BRIGGS RANCH

Preliminary Overall Area Development Plan P.U.D.

Re: Briggs Ranch (West)

POADP # 710

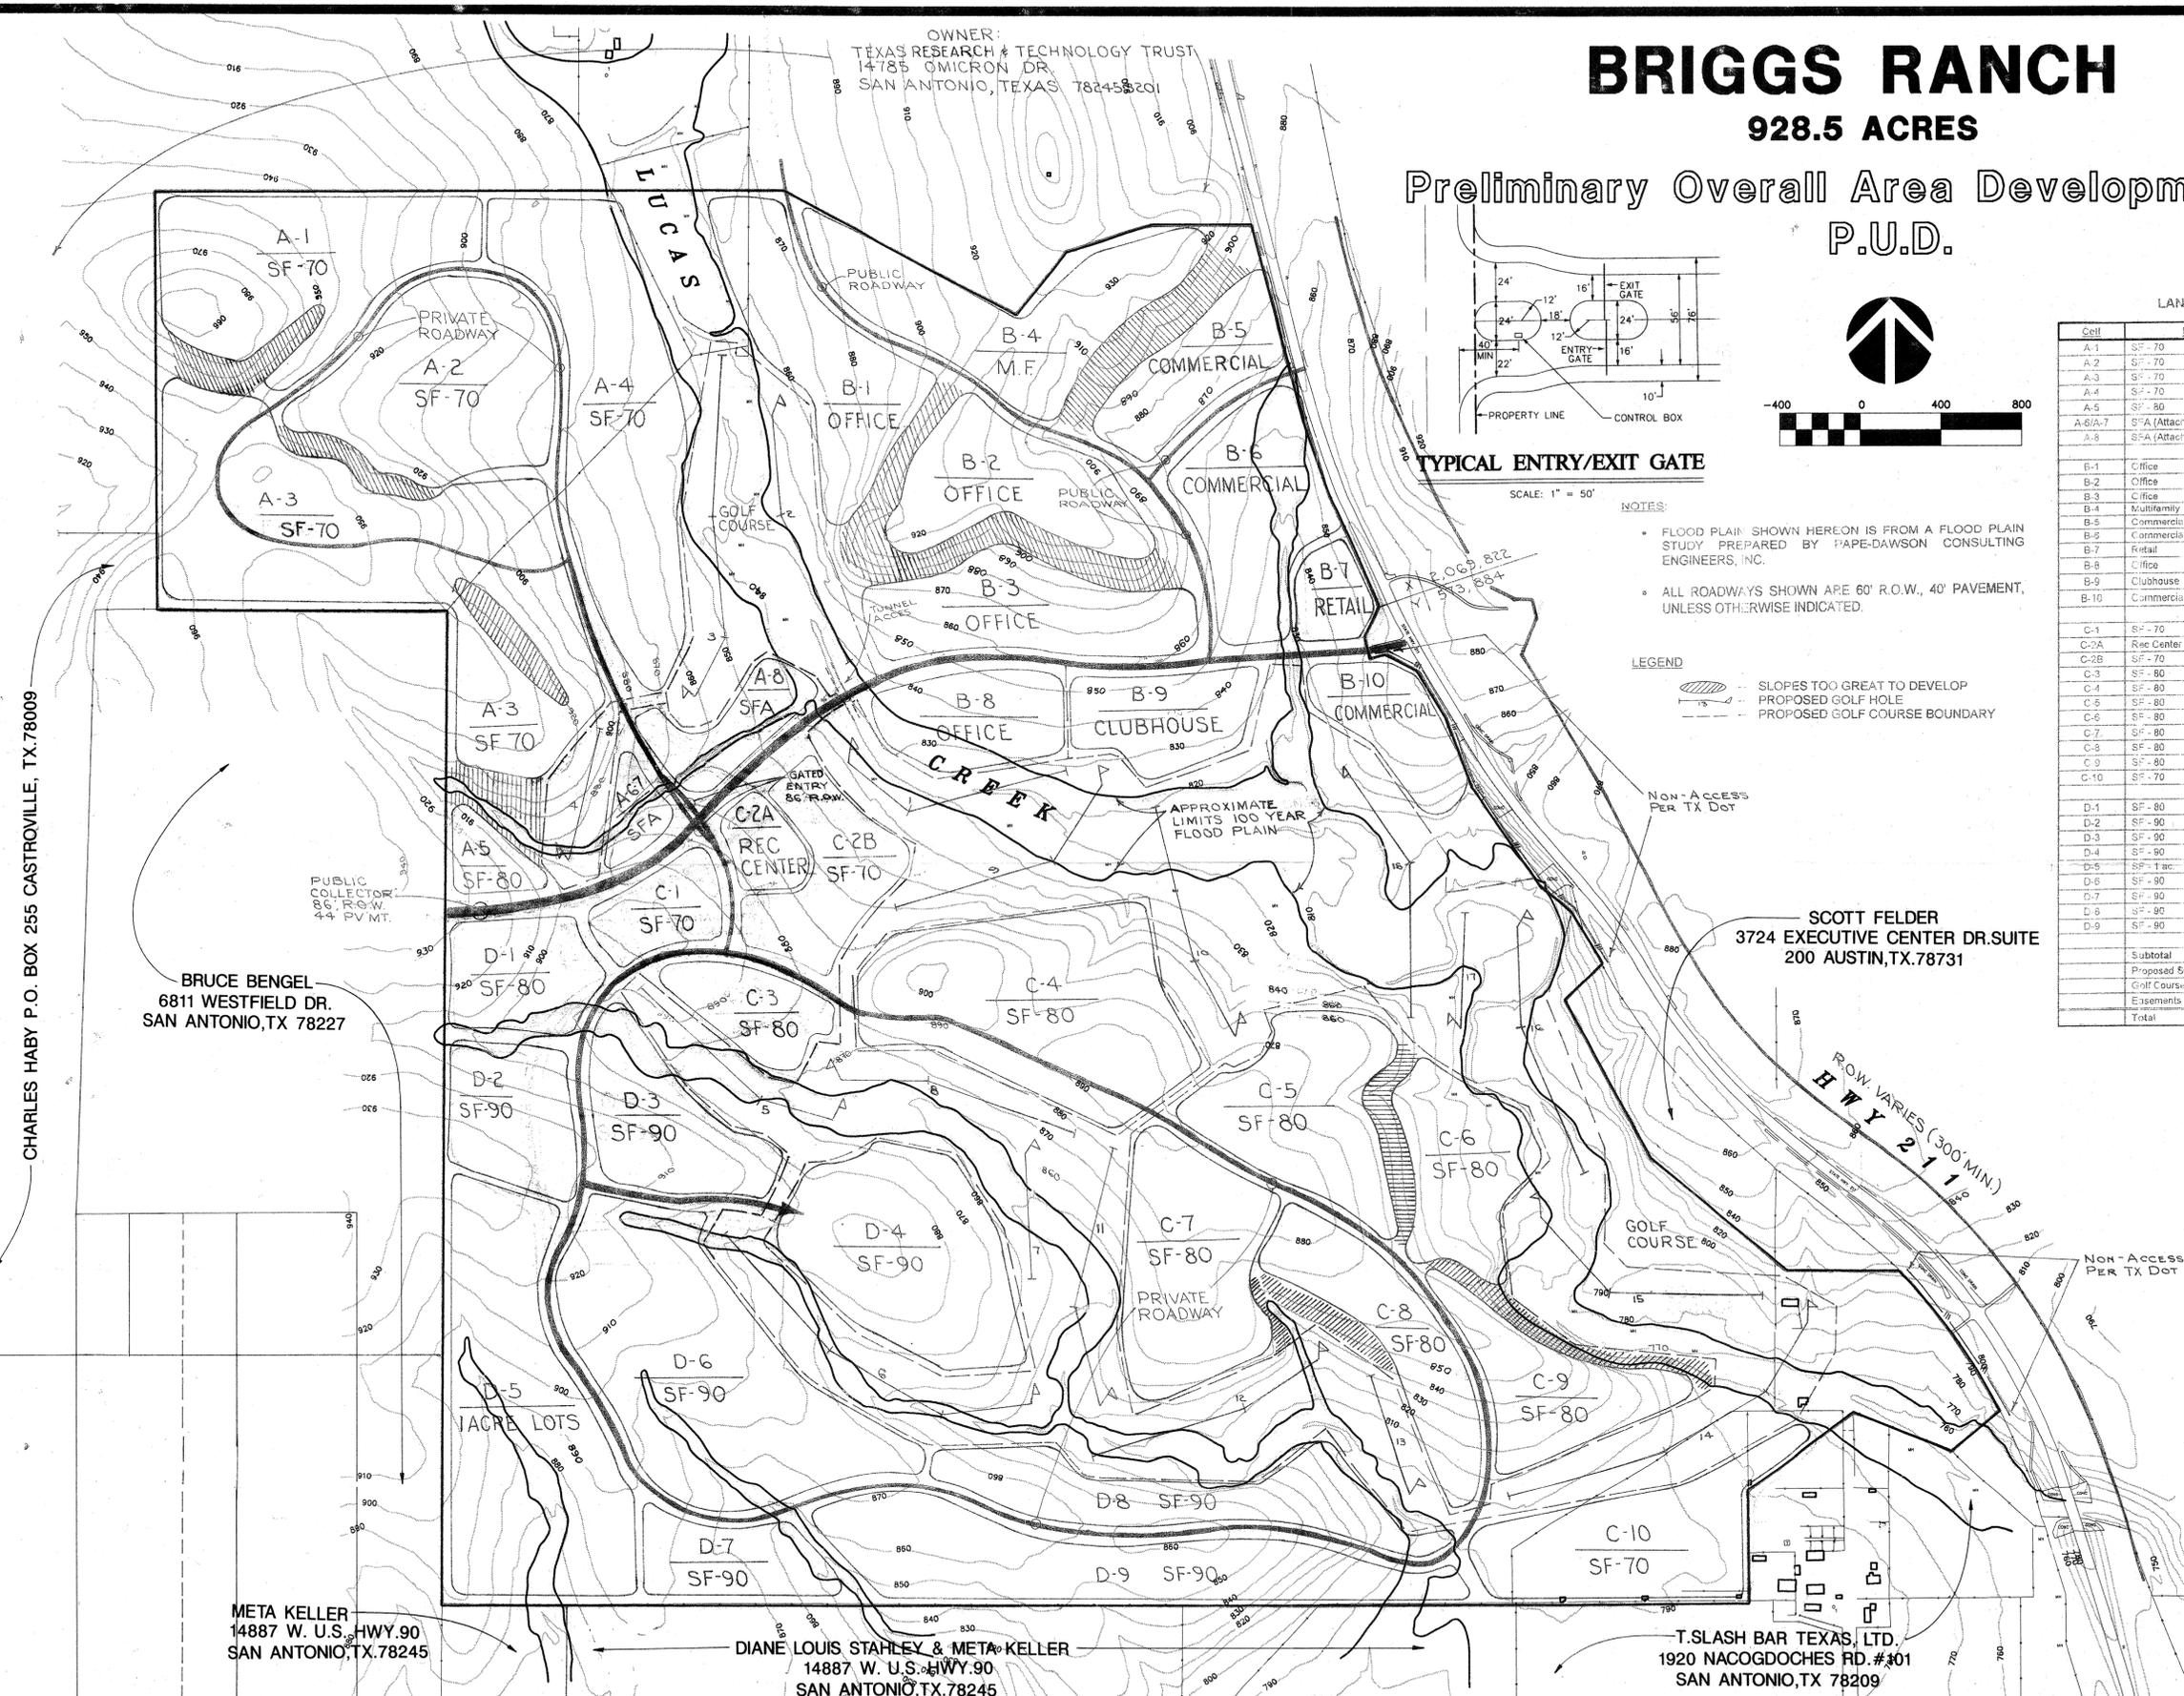
The City Staff Development Review Committee has reviewed Briggs Ranch (West) Preliminary Overall Area Development Plan # 710. Please find enclosed a signed copy for your files. Your plan was accepted, however please note the following:

- In consideration of public safety and convenience, excessive grades by reason of topography should be avoided in street layouts and arrangements.
- Access and R.O.W. issues along state facilities will need to be resolved with the Texas Department of Transportation (TXDOT). For information about these requirements you can contact TXDOT at 615-5814.
- This development will need to comply with tree preservation ordinance #85262. For information about these requirements you can contact Building Inspections at 207-7102.
- It will be expected that you will plat all of the property depicted in your POADP, to include: floodplains, drainage areas and open space.
- I would encourage you to work closely with the school district, so that they can plan accordingly.
